HISTORIC AND DESIGN REVIEW COMMISSION

HDRC CASE NO: 2019-357
ADDRESS: 831 LAMAR ST
LEGAL DESCRIPTION: NCB 1368 BLK 5 LOT 21
ZONING: R-6, H
CITY COUNCIL DIST.: 2
DISTRICT: Dignowity Hill Historic District
APPLICANT: Octavio Viramontes/HACAM PROPERTIES LLC
OWNER: Octavio Viramontes/HACAM PROPERTIES LLC
TYPE OF WORK: Construction of a 1-story, single family residential structure
APPLICATION RECEIVED: June 21, 2019
60-DAY REVIEW: August 20, 2019
CASE MANAGER: Edward Hall
REQUEST:

The applicant is requesting a Certificate of Appropriateness for approval to construct one, 1-story single-family residence on the vacant lot at 831 Lamar, located within the Dignowity Hill Historic District.

LANDSCAPING PLAN
3/16' = 1'-0"

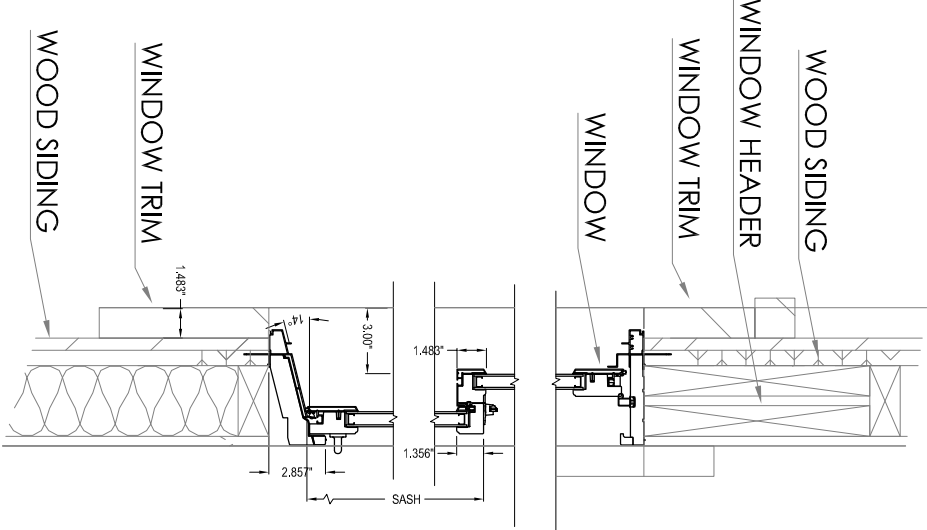
- n. **LANDSCAPING** – The applicant has noted a material that appears xeric in nature. Staff does not find the wholesale removal of grass and installation of decomposed granite or a similar material without natural ground cover to be appropriate. Staff finds that the applicant should submit a detailed landscaping plan for review and approval.

- vii. That the applicant submit a detailed landscaping plan for review and approval as noted in finding n.

ALUMINUM CLAD WOOD WINDOWS
MIRA PREMIUM SERIES: ALUMINUM CLAD WOOD WINDOW DOUBLE-HUNG

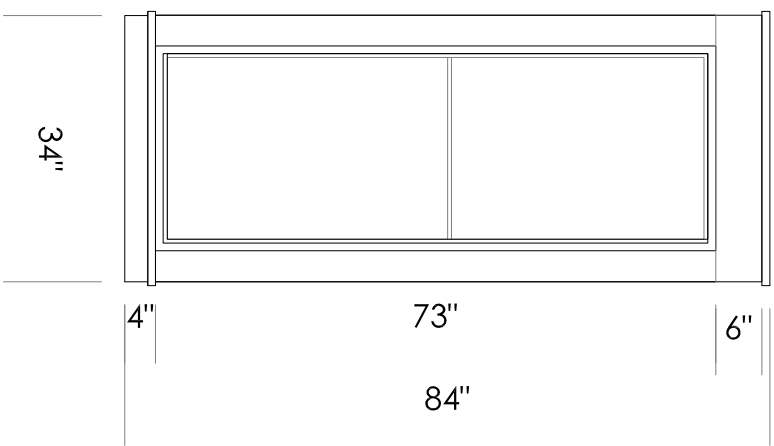
- k. **WINDOW MATERIALS** – The applicant has proposed aluminum clad wood windows. Staff finds the proposed windows to be appropriate; however, meeting rails must be no taller than 1.25" and stiles no wider than 2.25". White manufacturer's color is not allowed, and color selection must be presented to staff. There should be a minimum of two inches in depth between the front face of the window trim and the front face of the top window sash. This must be accomplished by recessing the window sufficiently within the opening or with the installation of additional window trim to add thickness. Window trim must feature traditional dimensions and architecturally appropriate sill detail. Window track components must be painted to match the window trim or concealed by a wood window screen set within the opening.

- iv. That the proposed wood columns feature both capital and base trim and chamfered columns as noted in finding j.
- v. That the proposed windows feature meeting rails that are no taller than 1.25" and stiles no wider than 2.25". White manufacturer's color is not allowed, and color selection must be presented to staff. There should be a minimum of two inches in depth between the front face of the window trim and the front face of the top window sash. This must be accomplished by recessing the window sufficiently within the opening or with the installation of additional window trim to add thickness. Window trim must feature traditional dimensions and architecturally appropriate sill detail. Window track components must be painted to match the window trim or concealed by a wood window screen set within the opening.

TYPICAL COLUMN
WOOD COLUMN AND DETAILS

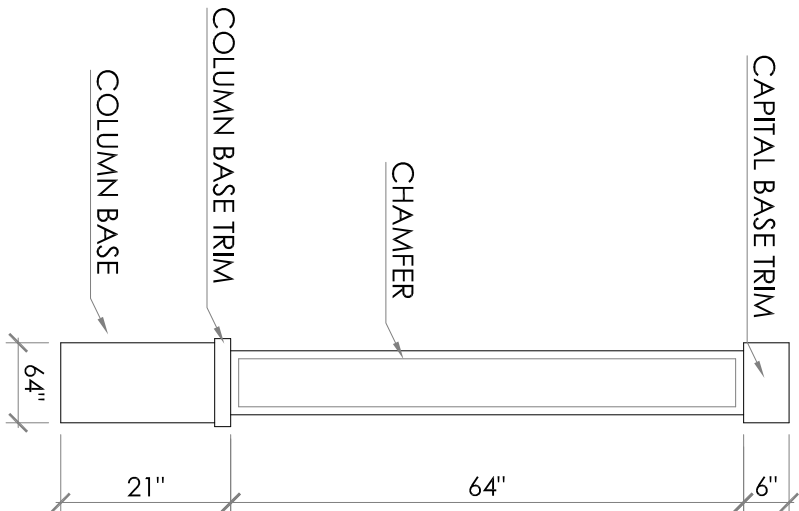
- j. **MATERIALS** – The applicant has proposed materials that includes profile 117 wood siding, 8 inch square wood columns, 4 inch wood trim and architectural shingles. Staff finds the proposed materials to be appropriate; however, staff finds that the proposed wood columns should feature both capital and base trim and should feature chamfered corners.
